# Technical Bulletin

February 2025

## NV200 Spectral | New Cashbox

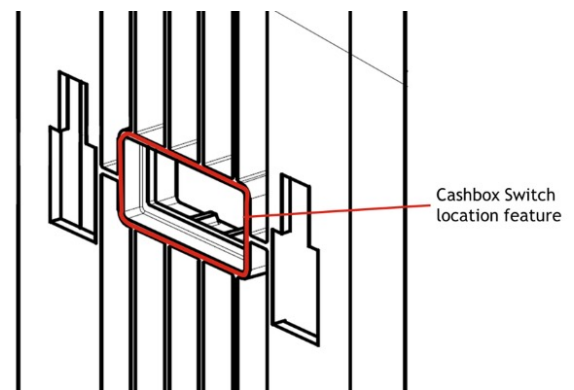
As part of continual improvement efforts, the NV200 Spectral cashbox stacking reliability has been improved. The colour of the door has also been updated to provide a visual queue for the change. These cashboxes are available during Q1.

### Chassis | Build Revision 5

- Addition of tear drops at the rear to aid rear mounting
- Slot added to rear of chassis to allow for an independent low powered cashbox present switch
- Side screws in the chassis have been removed
  - If these are still required, please let your Sales Manager know for future orders. Part number (SC02026).
- Finally, with the Chassis becoming standard, its need to be interchangeable so the chassis now fits an NV200ST and cashboxes (see next page).

### Docking Plate | Build Revision 3.3

To line up with the changes to the chassis, a location feature has been added for an independent low-powered cashbox present switch.

## NV200ST | Build Revision 3.2

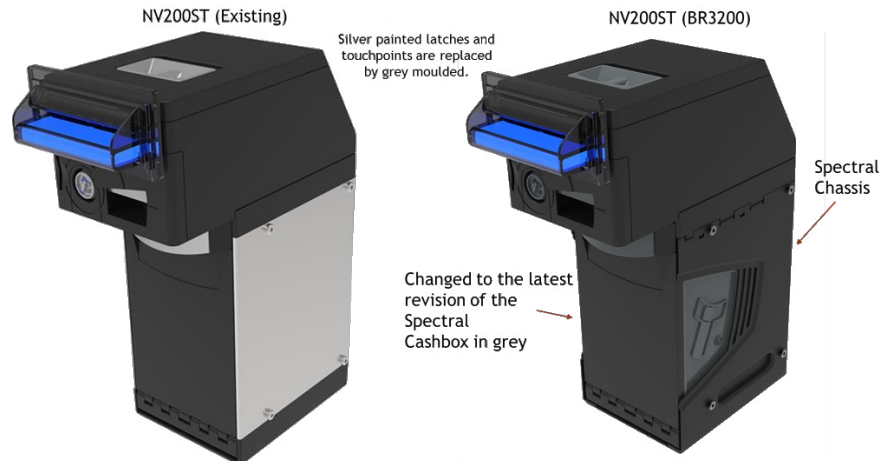
The NV200ST has inherited all of the latest changes from the Spectral chassis and cashbox, to identify an ST cashbox from a Spectral cashbox the plastics have been changed to grey, the silver latches in the validator have also been updated to grey to match. This NV200ST variant is available from Q2.
